August 25, 2017

**RE: Lot 19 Block 4 Unit 19 Volcano Cliffs SAD 228
6539 Vista Del Prado NW
Grading and Drainage Plan
Engineers Stamp Date 8/18/17 (D10D003T19)**

James D. Hughes, P.E.
Principal Engineer, Hydrology
Planning Department

ENGINEER'S SEAL	6539 VISTA DEL PRADO MAESTAS RESIDENCE	DRAWN BY WCWJ
		DATE 8-19-17
	GRADING AND DRAINAGE PLAN	21779-LAYOUT-8-18-17
	8/18/17	 <i>Rio Grande Engineering</i> 1606 CENTRAL AVENUE SE SUITE 201 ALBUQUERQUE, NM 87106 (505) 872-0999
DAVID SOULE P.E. #14522	JOB # 21779

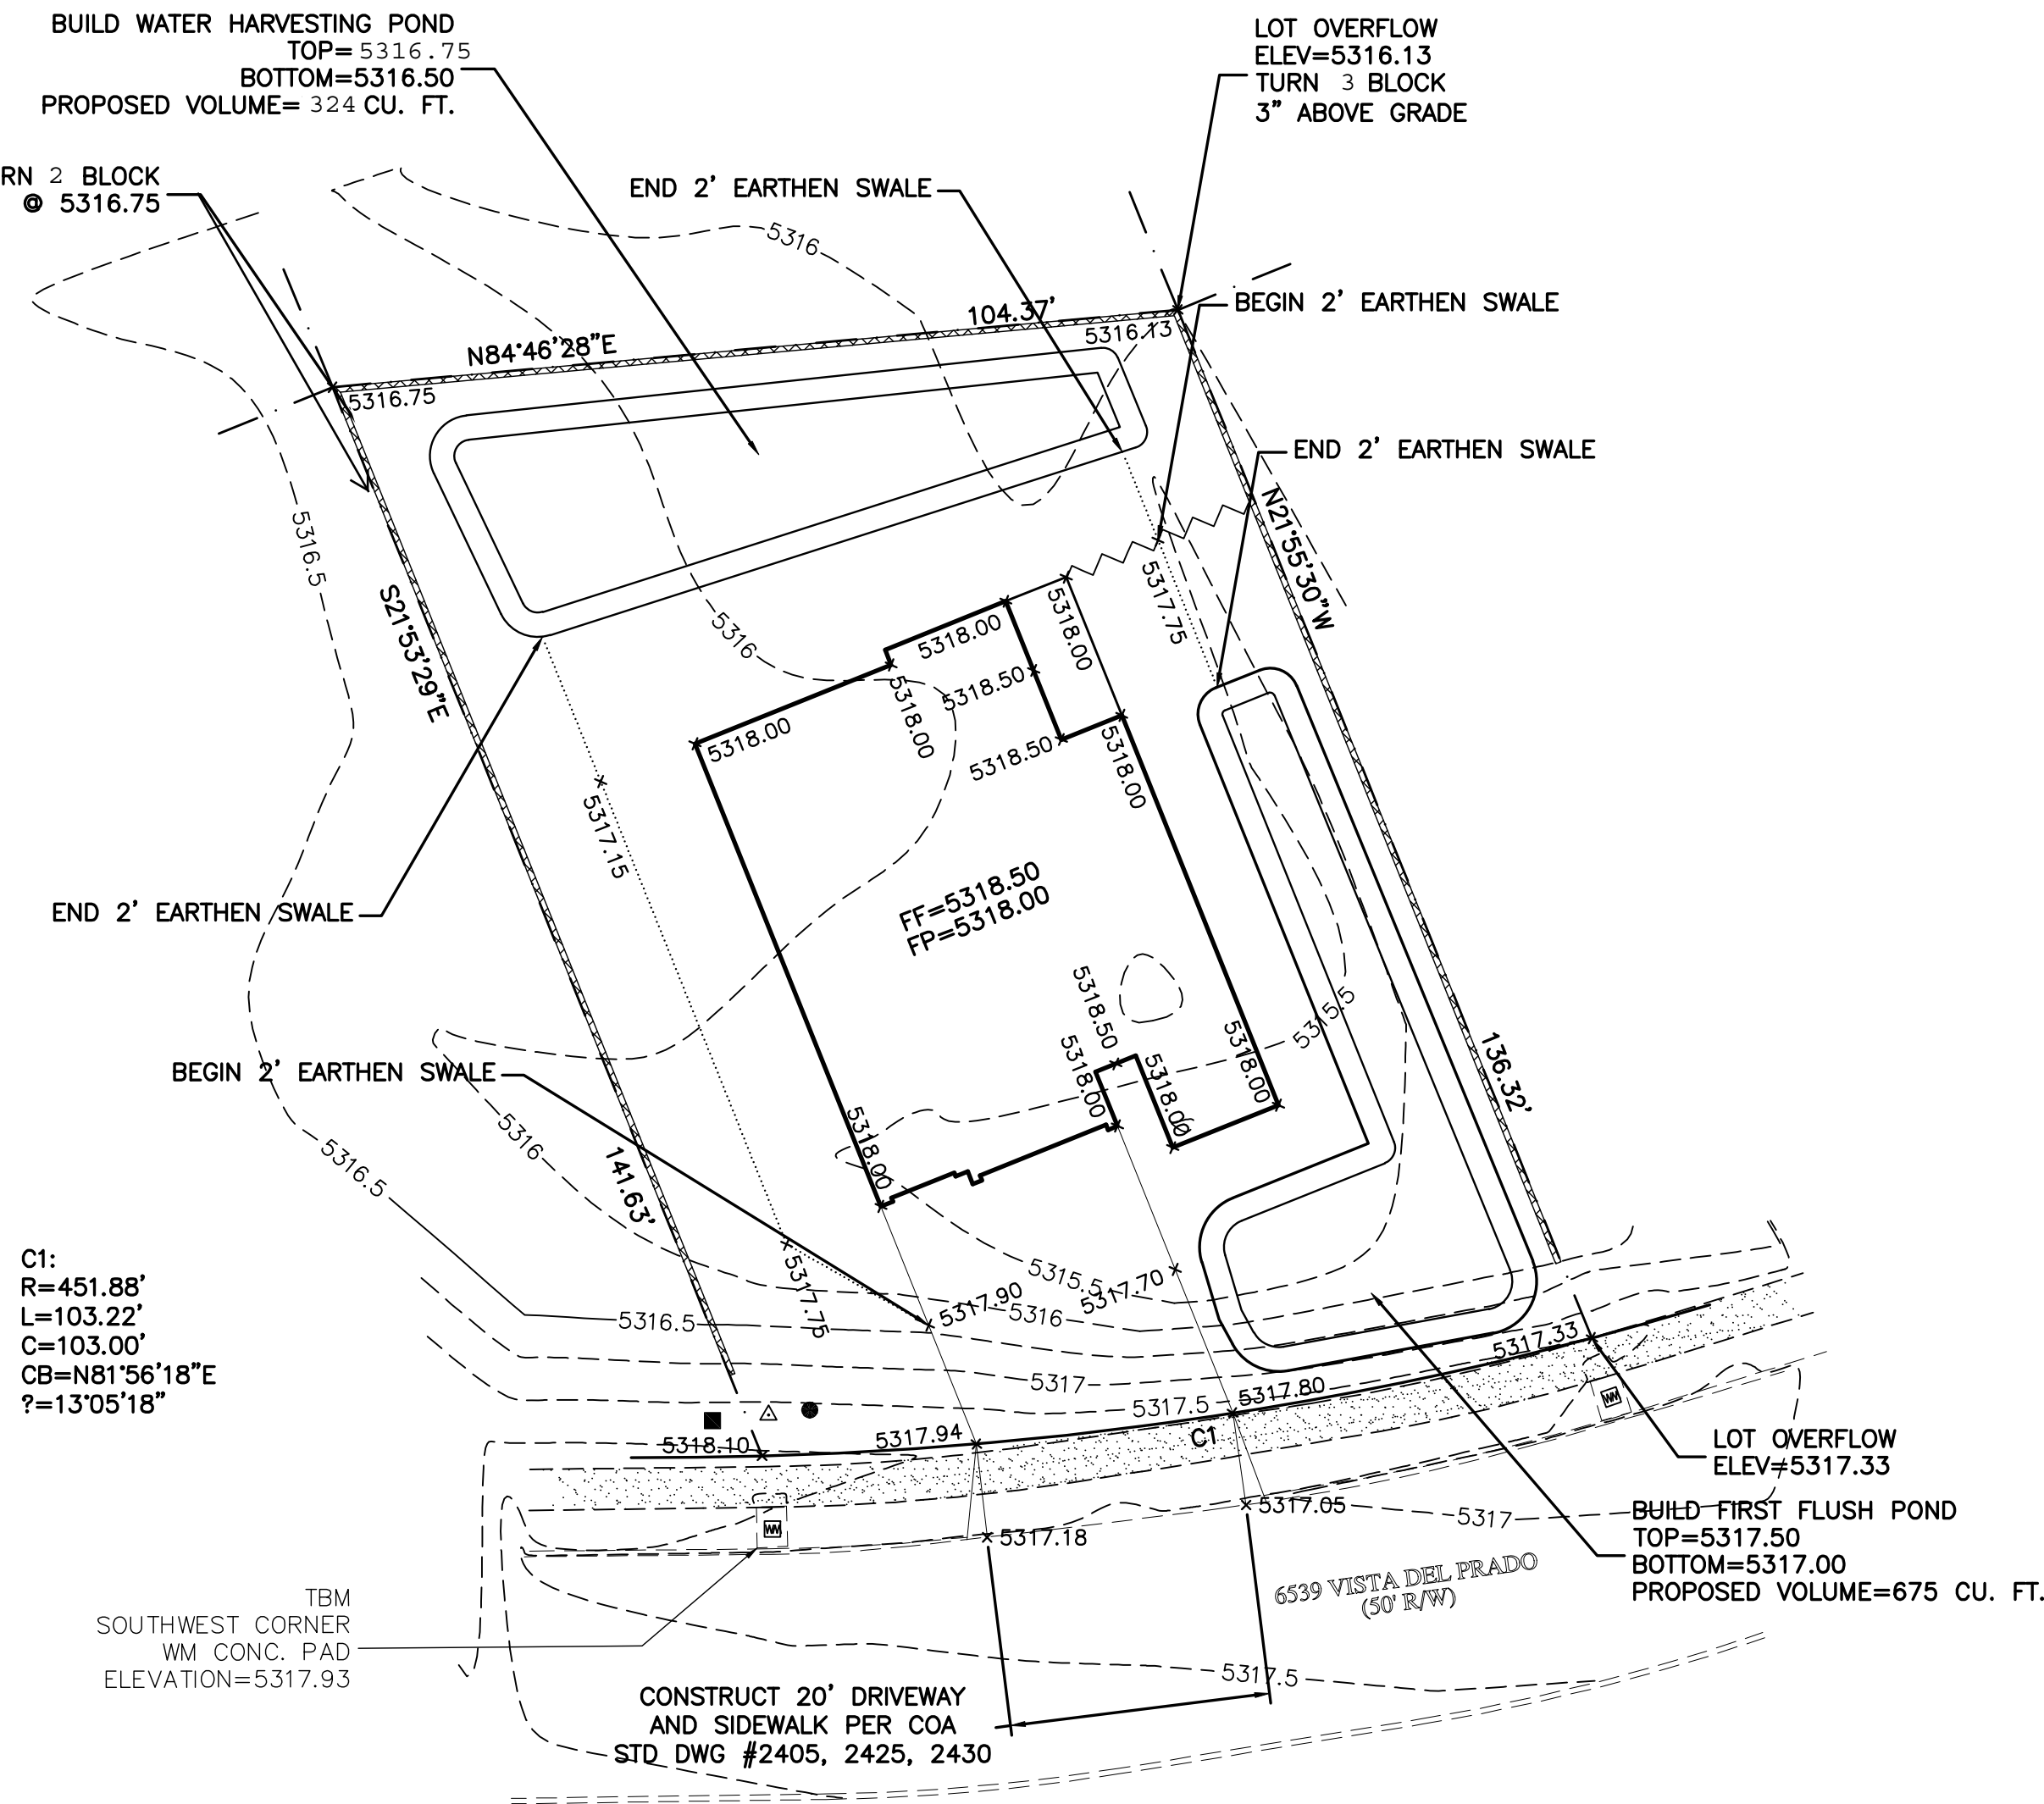
Based upon the information provided in your submittal received 8/21/17, this plan is approved for Grading Permit.

Please inform the builder/owner to attach a copy of this approved plan to the construction sets in the permitting process prior to sign-off by Hydrology.

Reiterate to the Owner/Contractor that a separate permit for a garden/retaining wall must be obtained, with the approved G&D plan dated 8/18/17.

Prior to Building permit approval a Pad Certification will be required, provided by the Engineer or a registered Land Surveyor.

Prior to Certificate of Occupancy release, Engineer Certification per the DPM checklist of this plan will be required.
